Re: 121-129 York St./Harborview Townhouses

**TO: CITY OF PORTLAND PLANNING AUTHORITY**  
**DATE: APRIL 14, 2011**  
**RE: REPLY TO LEVEL III SITE PLAN REVIEW COMMENTS DATED**  
**APRIL 12, 2011**

Subject: 127 – 129 York St.  
Owner Applicant: Harborview Development LLC

Subject: 127 York Street – Harborview Townhouses – 044-A-4 & 5 - #2011-214  
 Response to City Zoning Comments – dated 4/12/11

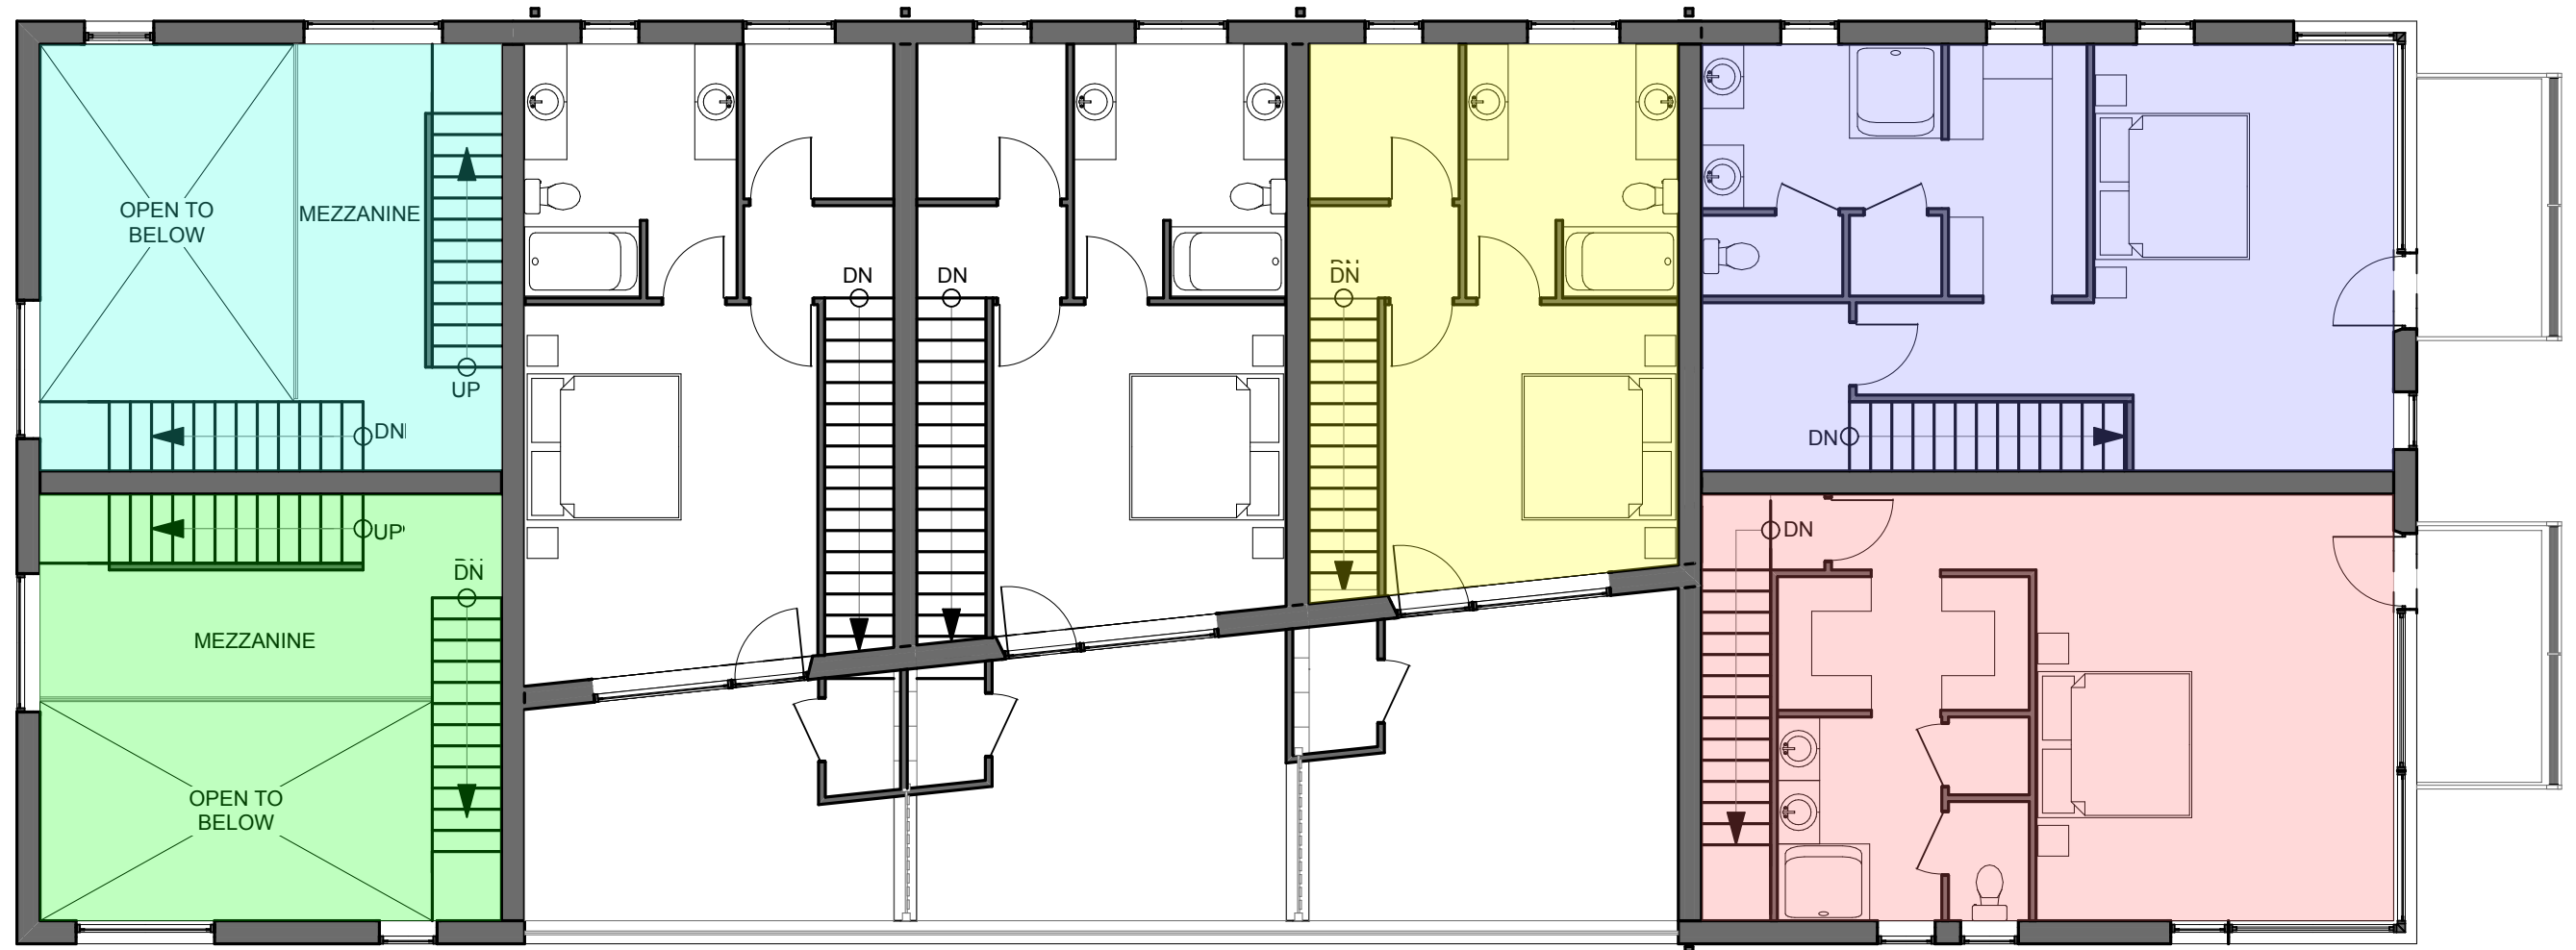
4. I do not think that the open space ratio was correctly determined. I would want supporting documentation concerning this. The open space cannot include impervious surfaces nor parking. It does not appear that 66% of the lot meets the definition of open space as defined in the Ordinance.

Acorn Engineering, Inc. on behalf of the project team is pleased to respond to the Comment 4 provided within your letter regarding the calculation of the open space ratio. As you mention the open space ratio was incorrectly determined. The open space ratio should have been calculated by dividing the total impervious area, provided below in Table 1, by the total lot area and then subtracting that ratio from one.

$$1 - (16,310 \text{ sf} / 21,239 \text{ sf}) = .23$$

An open space ratio of 23% is greater than the minimum required ratio of 20% for those lots which contain fewer than 20 dwelling units as defined in the City of Portland Land Use Ordinance 14-139 (h) 1.

1 Mezzanine/Third Floor

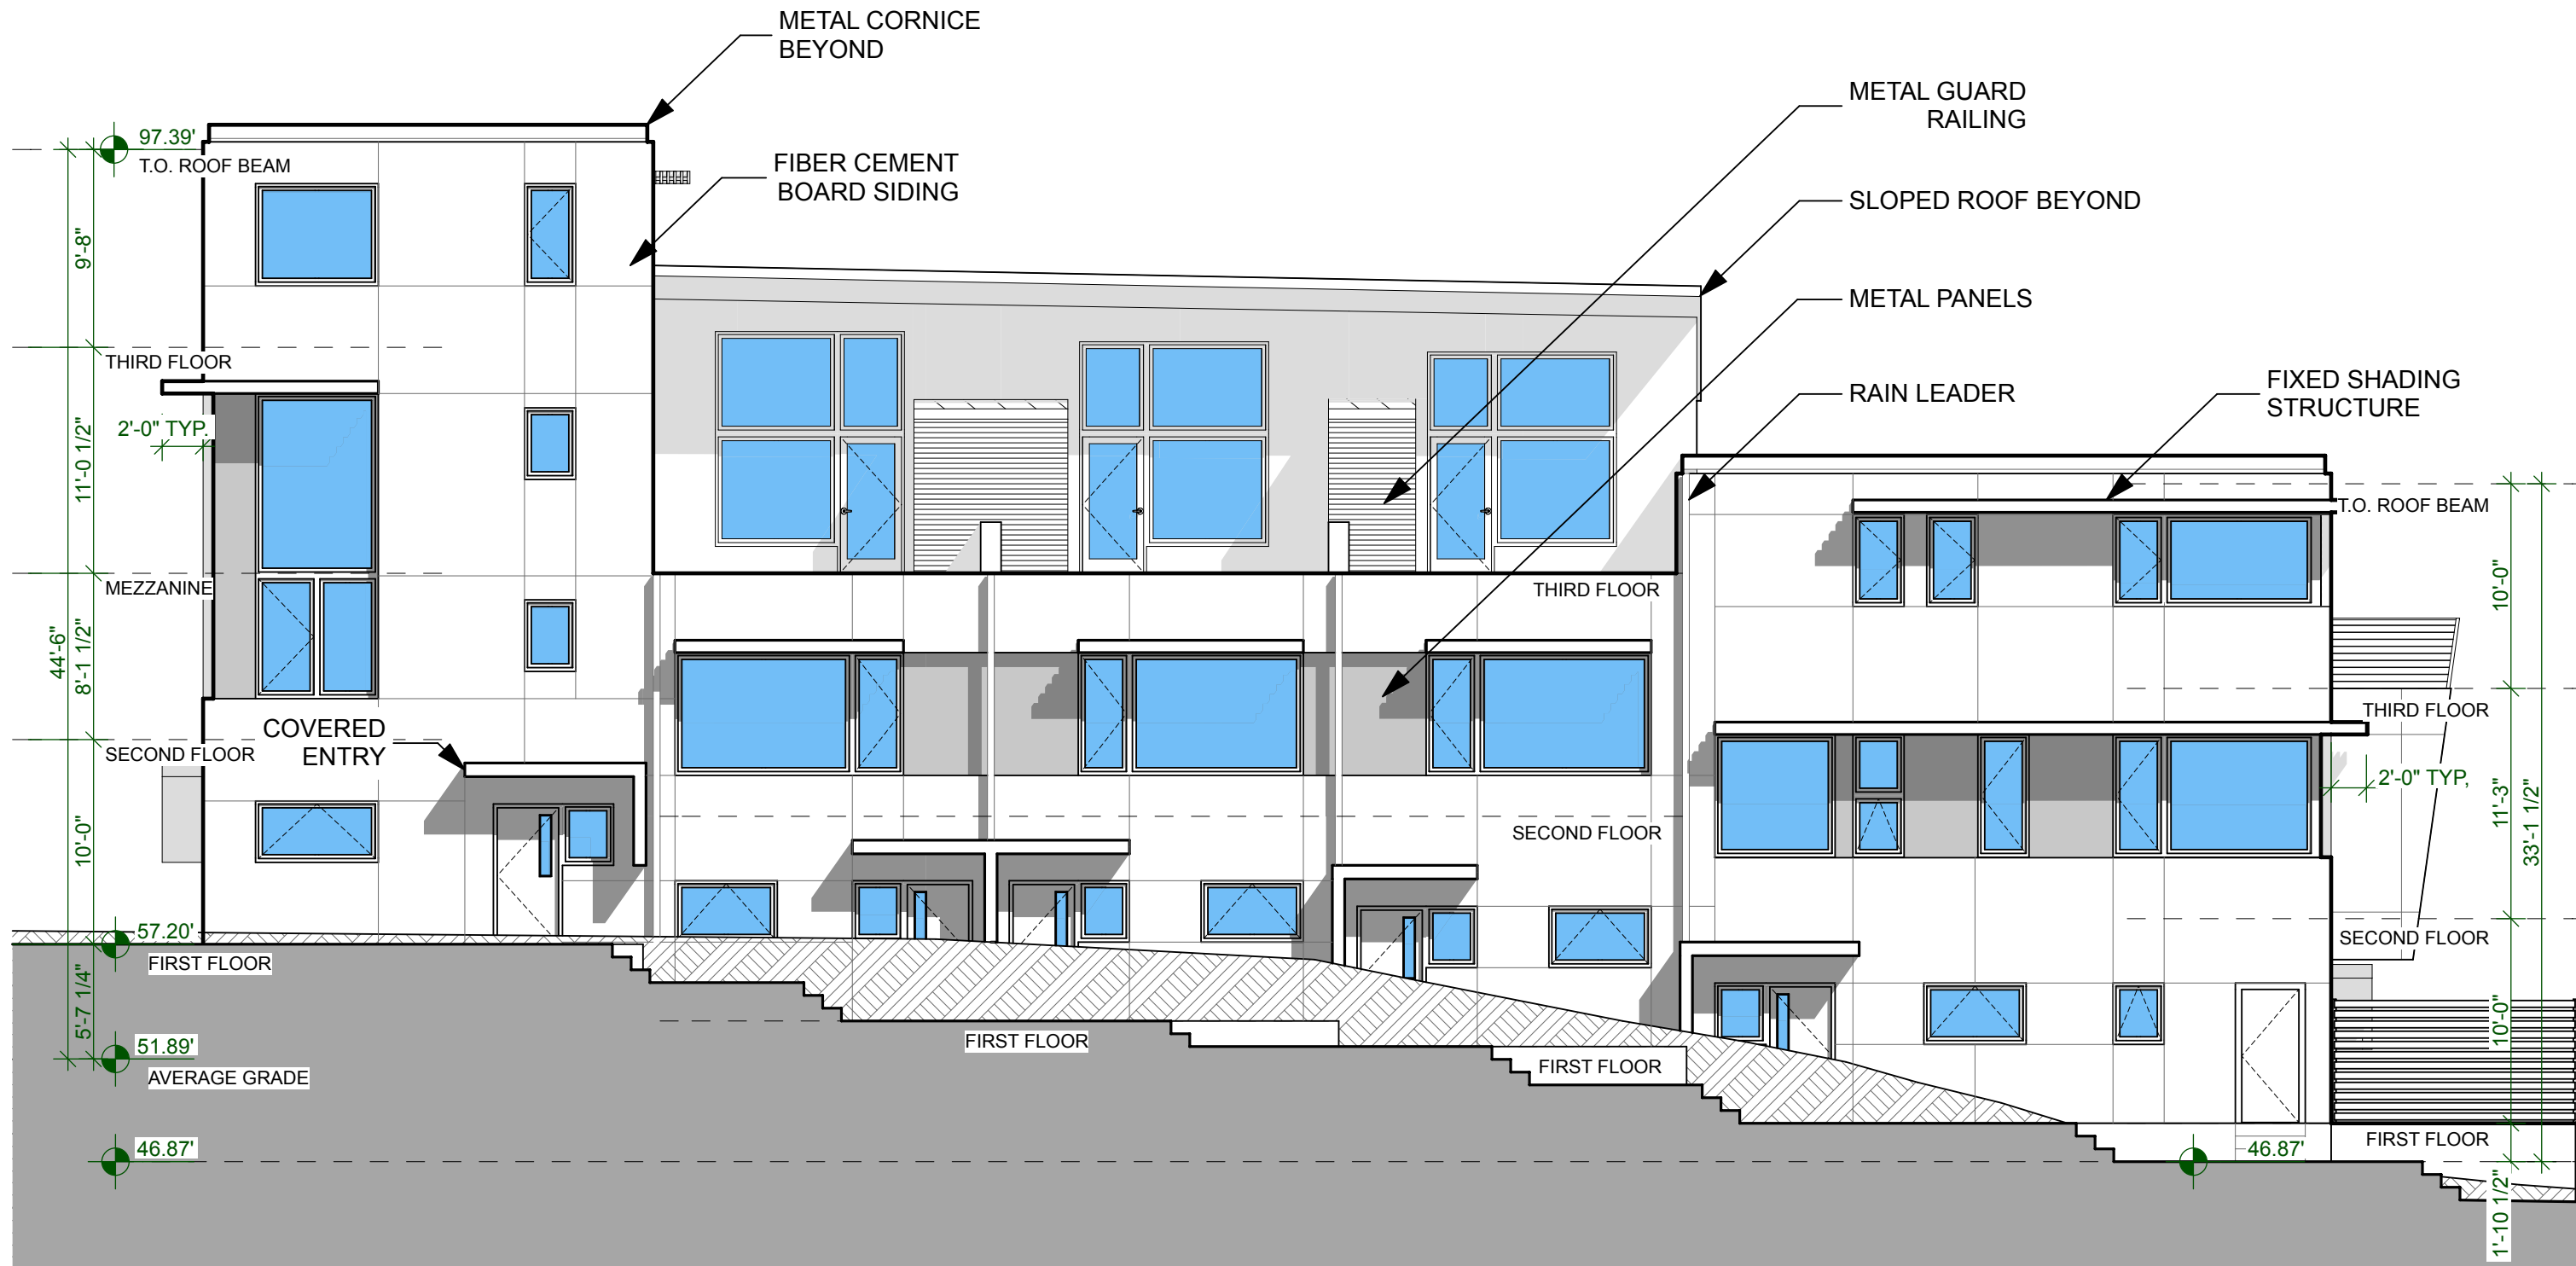
3. The building elevation sketches lead me to believe that the proposed building may be 4 stories and not three stories. I would need more information to analyze that compliance. If it turns out that this building is actually 4 stories, then the side setbacks are wrong on the plans. 12' instead of 10' would be required.

See again the attached, revised building elevation. The back two units have a mezzanine level between the second and third floor. As per 2009 IRC, Section R202 (p. 17), Definitions: Mezzanine, Loft. "An intermediate level or levels between the floor and ceiling an any story with an aggregate floor area of not more than one-third of the area of the room or space in which the level or levels are located."

1 **SOUTHWEST ELEVATION**

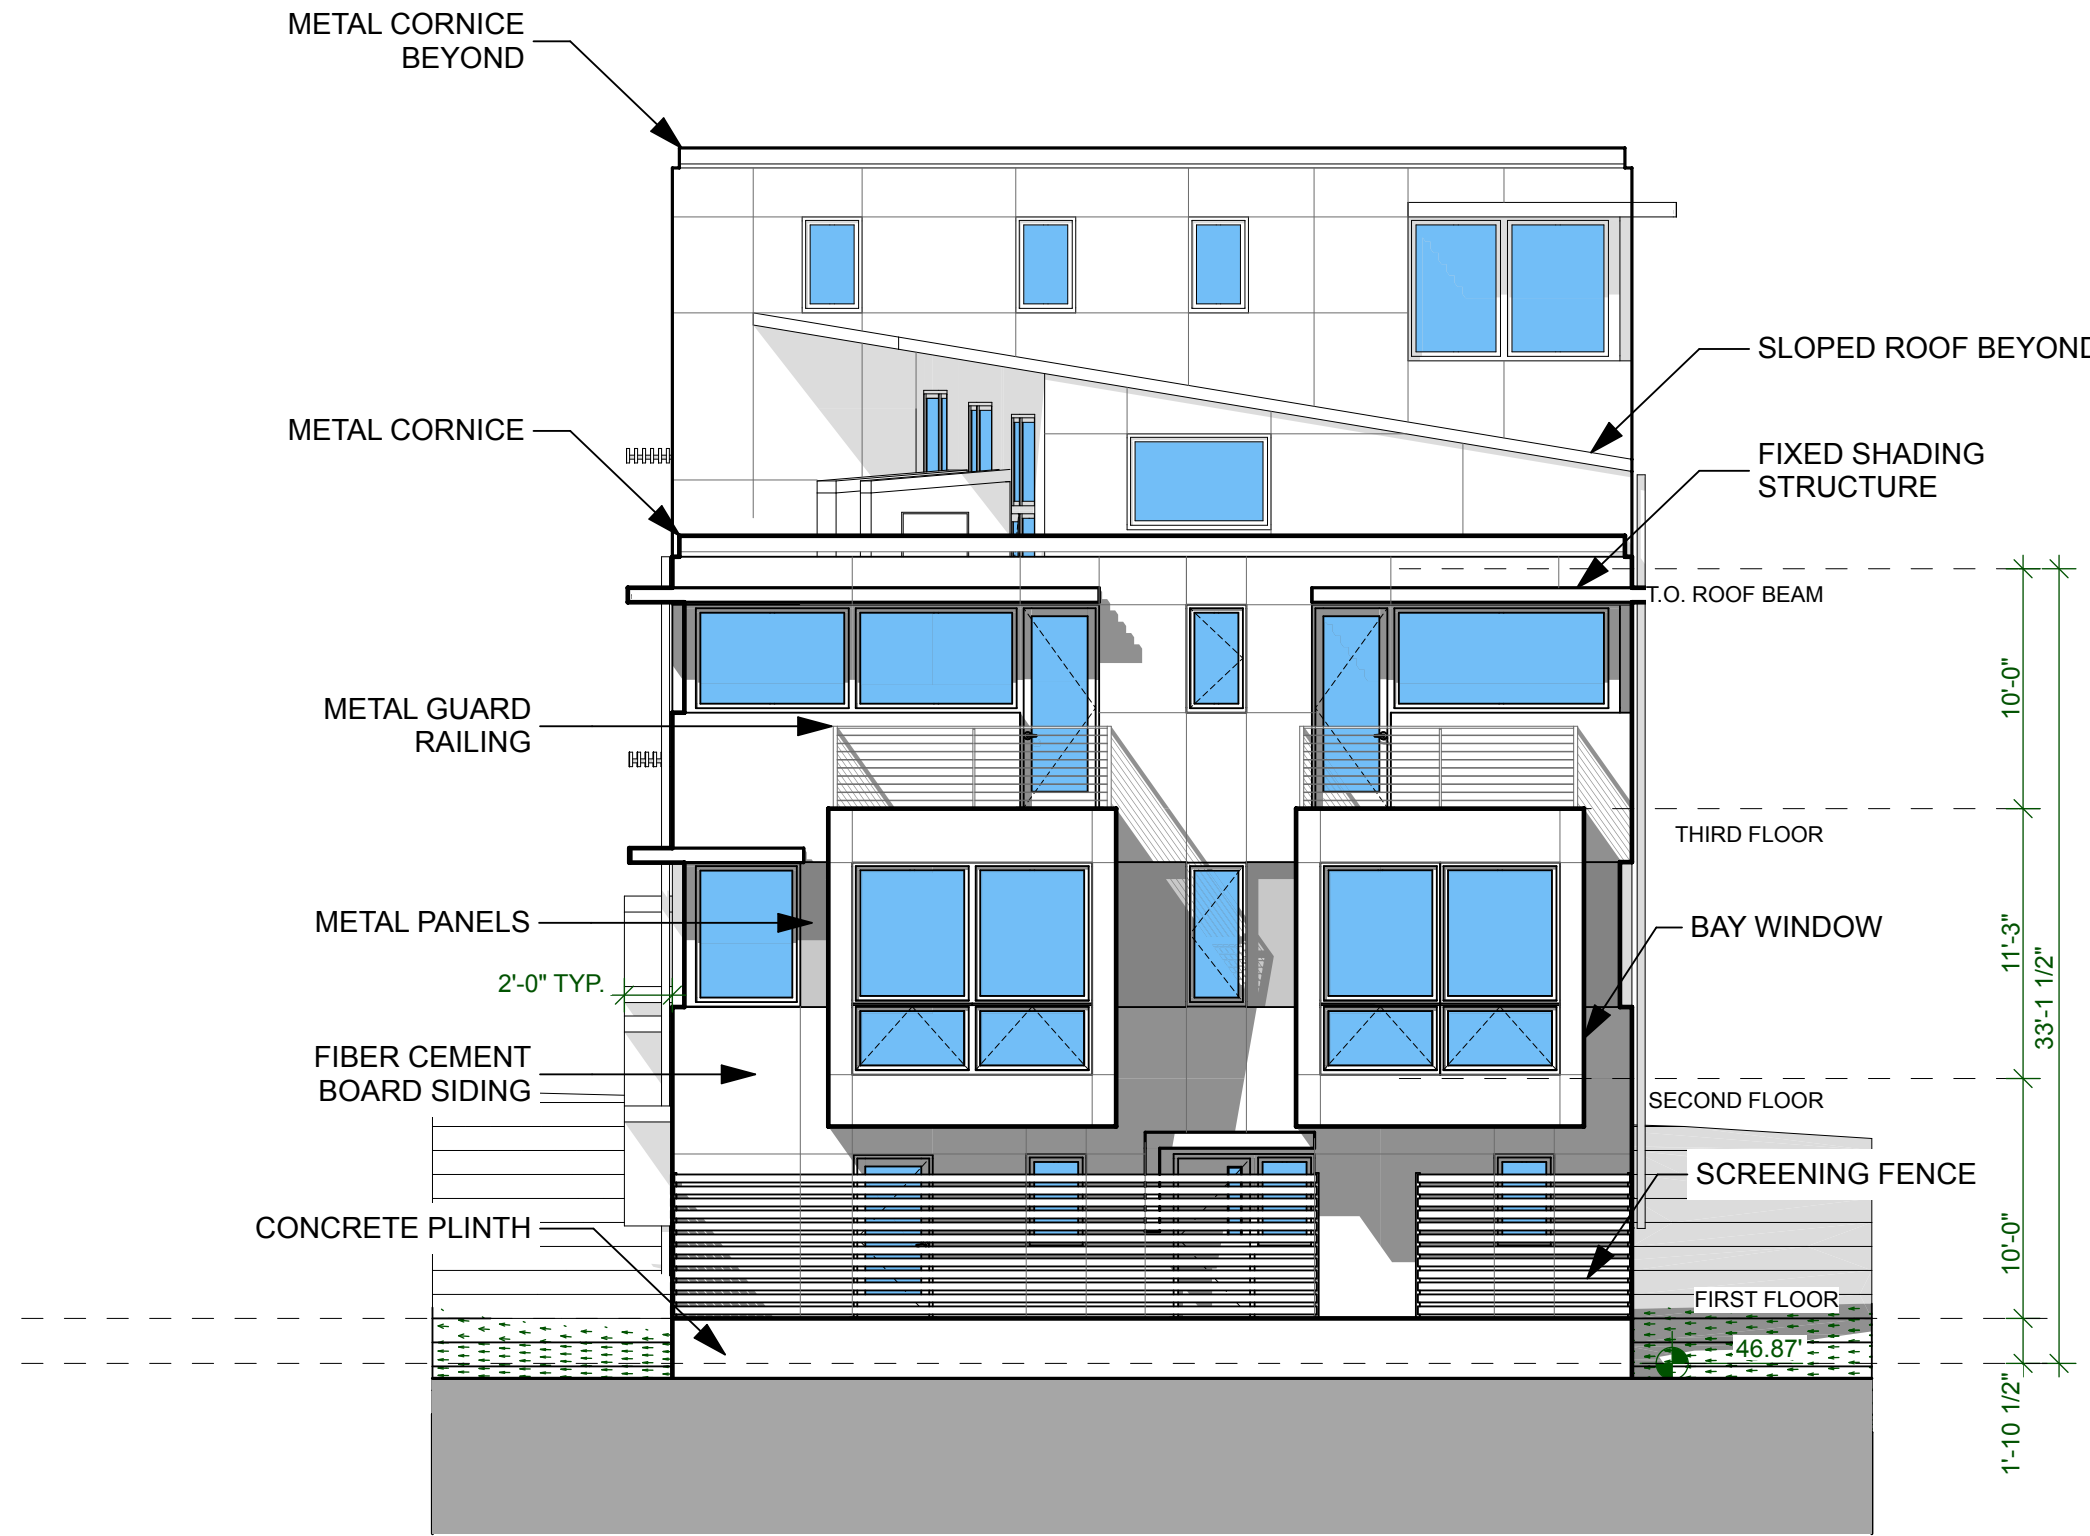
2. I was given the average grade, but I do not see the elevation of the top of the highest roof beam. Before I can determine the height of this building I would need to see that figure.

Please see the attached, revised building elevation. The roof beam at the tallest part of the building is 44'-6" above grade.
